10074
17/8
Re. Building on plot No. 659. J. M. 3.

Plan No. 41/7 Jm3 Sheet Janstad Qr.Plan for BungalowThe above plot submitted by Mr. Santbas Dammal

With reference to your application dated 20th October 1939,
with a plan for the proposed buildings/additions and alterations on plot
No. 659 Survey Sheet No. J.M.3, Jamshed Quarter,
I have to request you to comply with the following requirements—

AMENDED PLAN OF BUNGALOW ON
PLOT N^o 659 (42/10) J.M., 3, JAMSHET Q^r

AMENDED PLAN OF BUNGALOW ON PLOT NO. 659 (42/10) J.M., 3, JAMSHET Q.R.

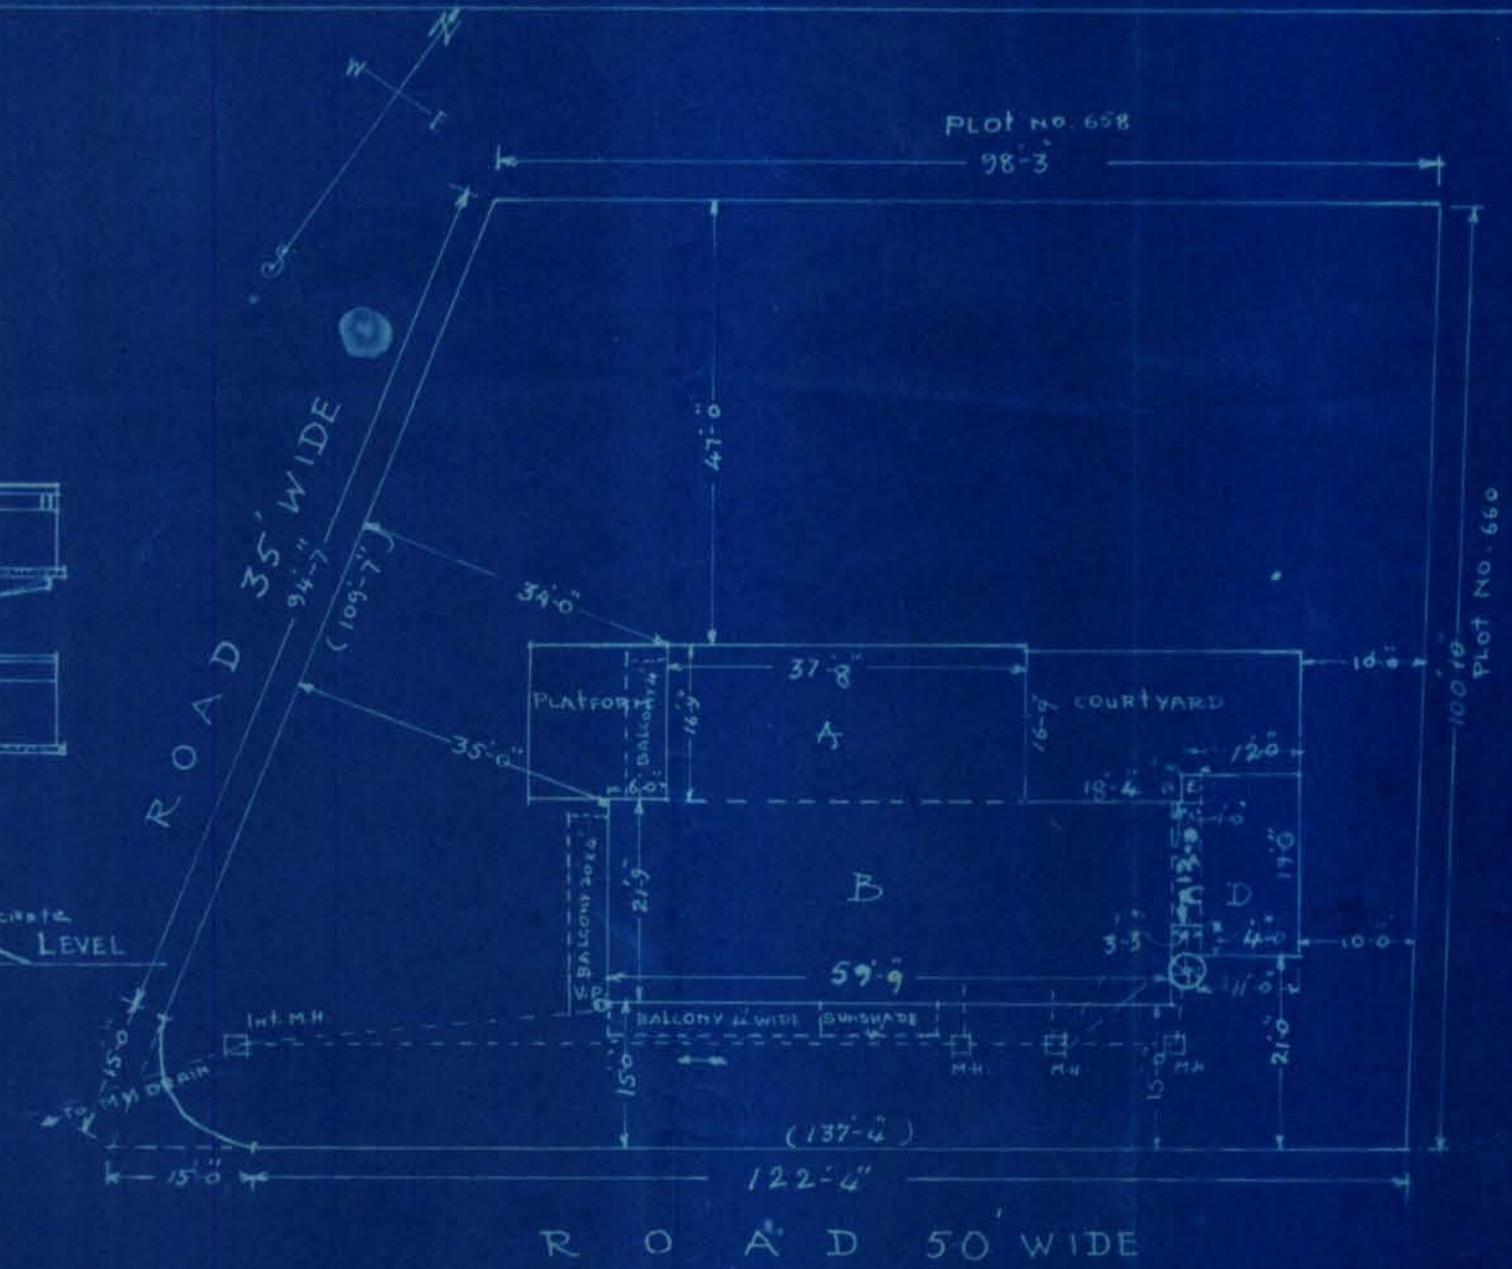
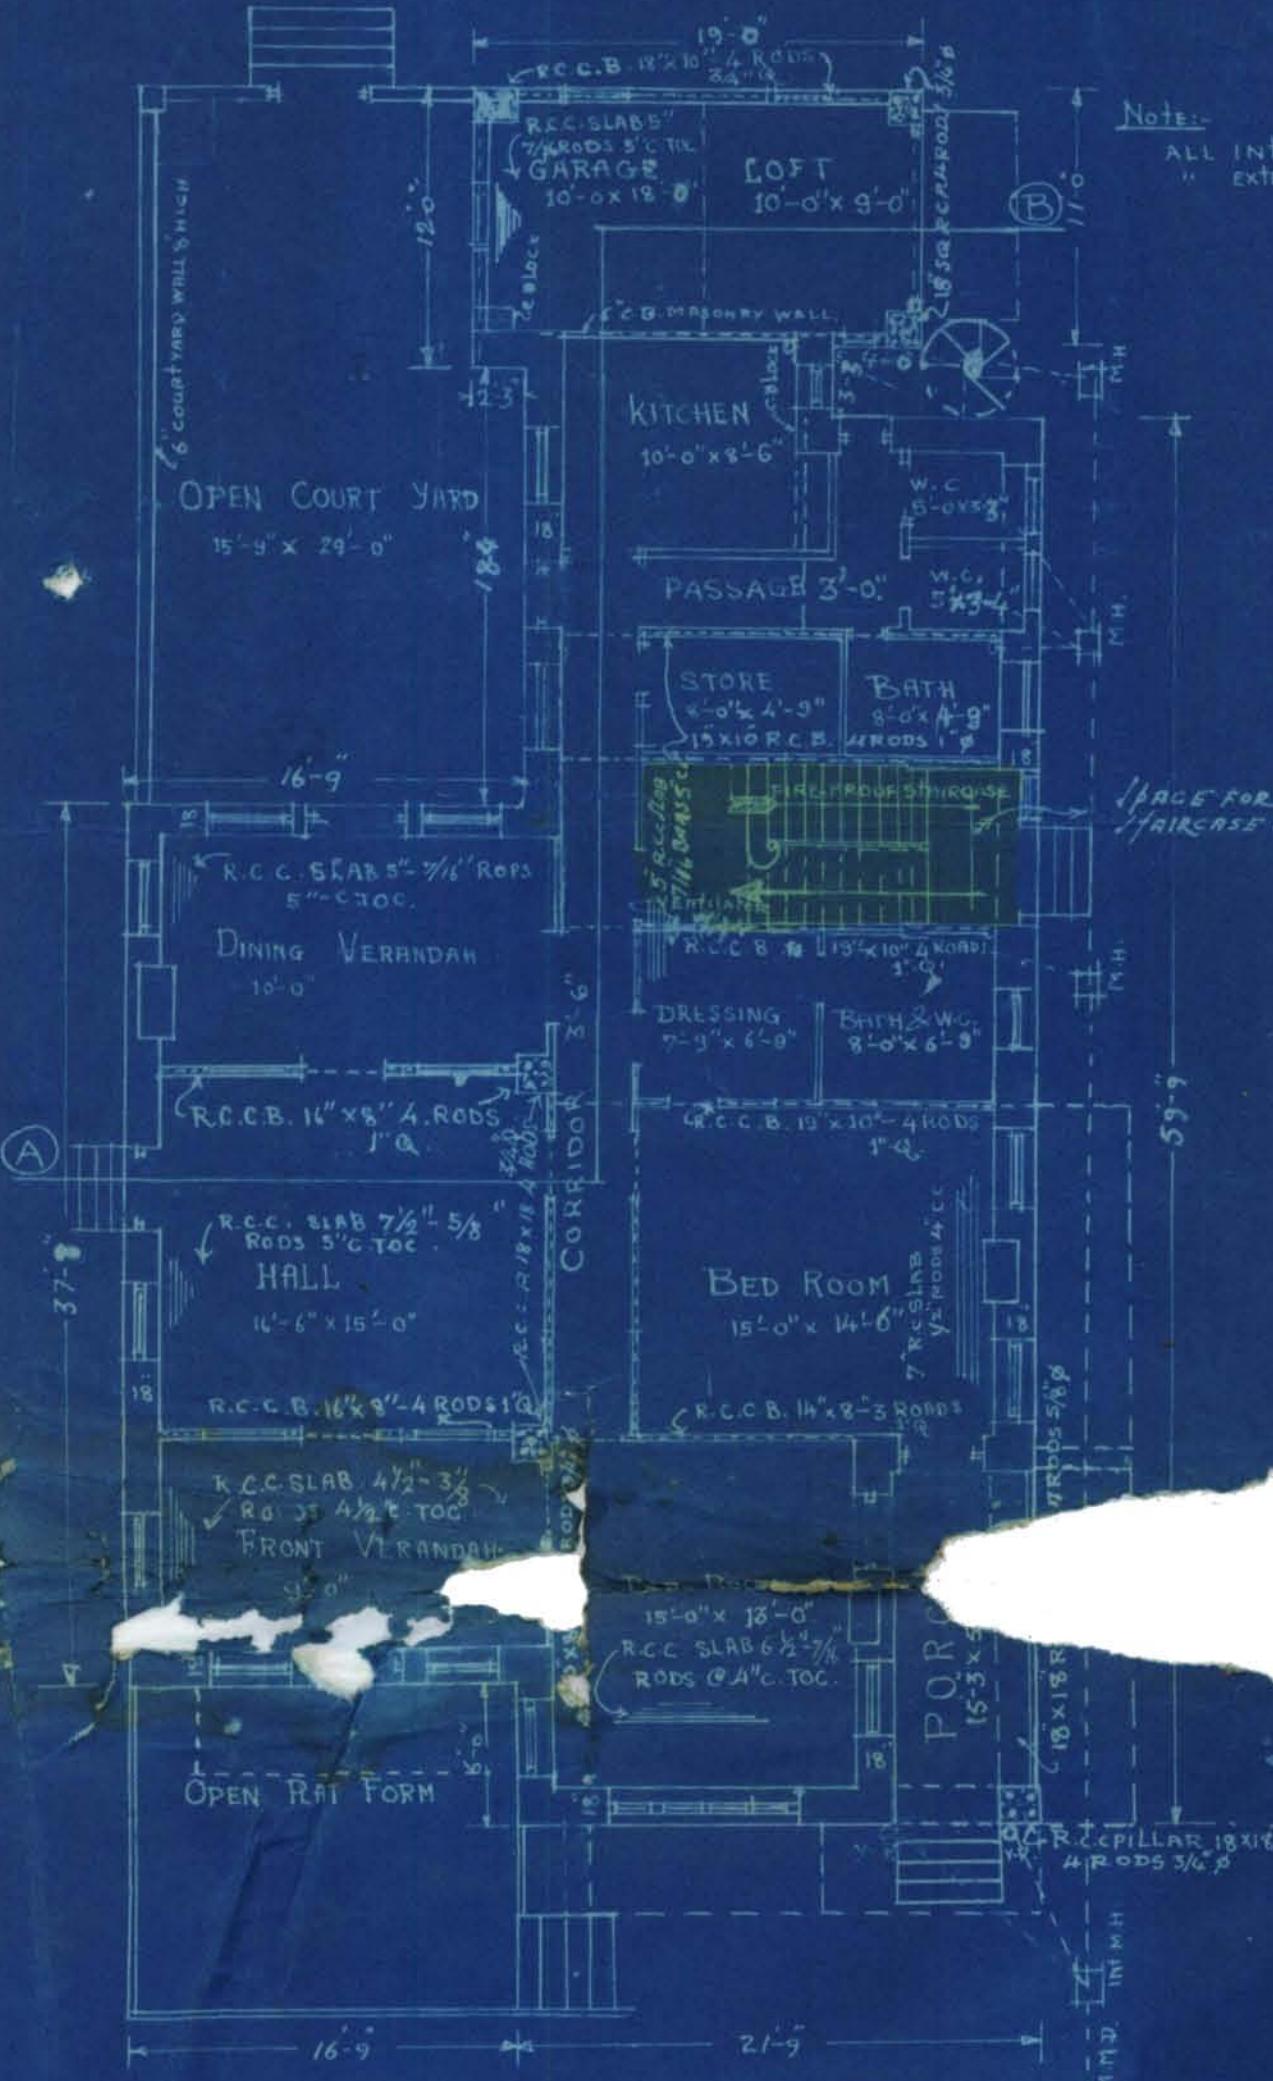
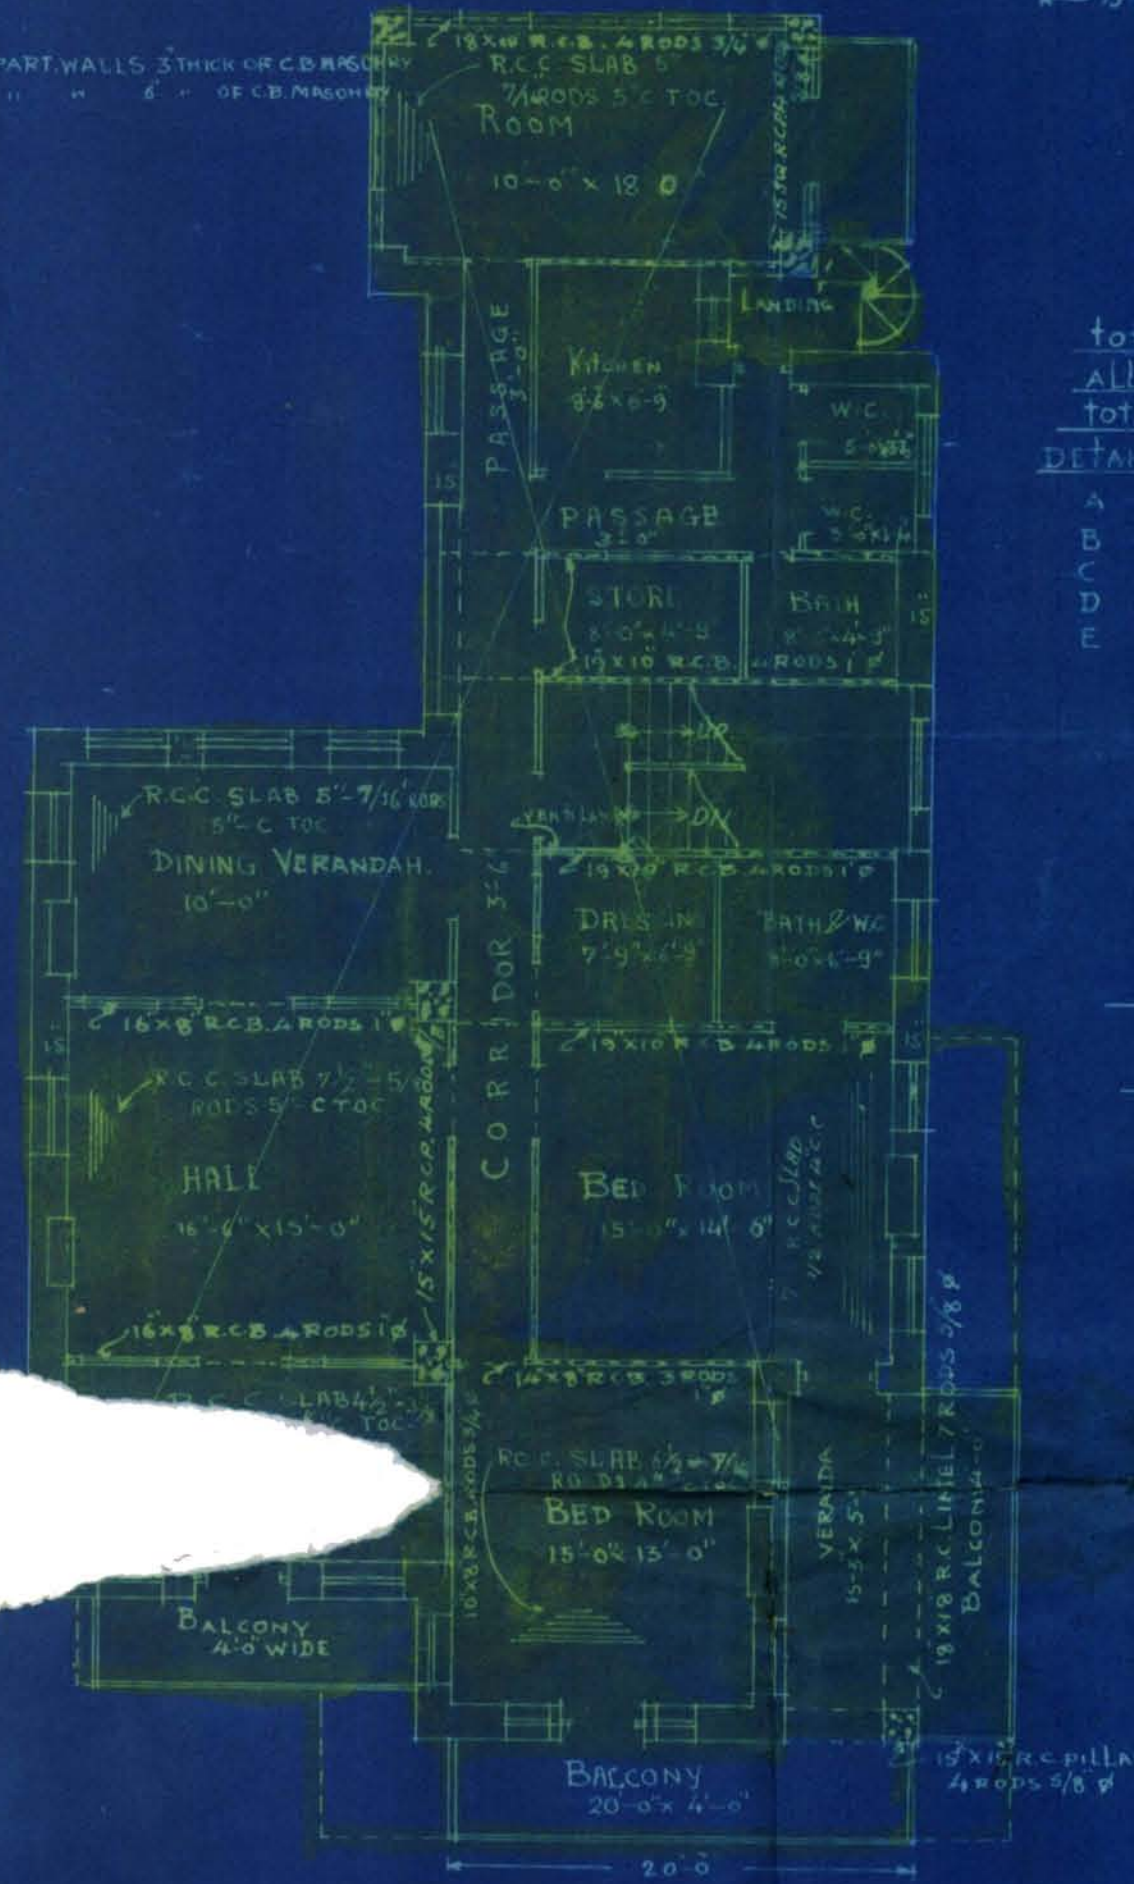
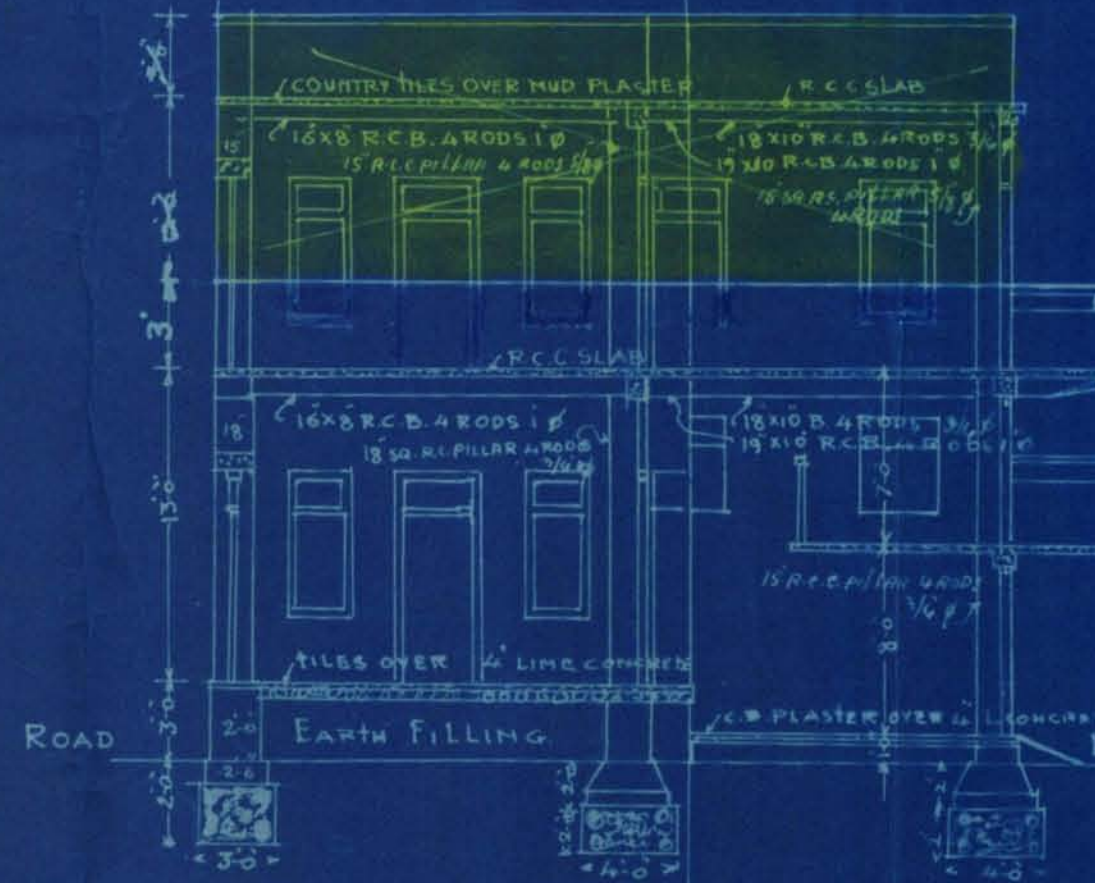
Re objection 4, we submit that the balconies may be allowed as in case of Baysan on plot no 50 C.F. 2. Chitra Qr. no. only balcony but even open stair-case has been allowed in compulsory open space where the sale conditions are identical.

Re Obj 5, the so called balcony is only a landing + keeping food on the top.

Re Obj 6, the landing is quiet in and will be ~~not~~ covered on top.

Re Obj 7, the dressing room has sufficient light + air as it has a door a bed and a window. However a further ventilator has been provided in the landing which fans open.
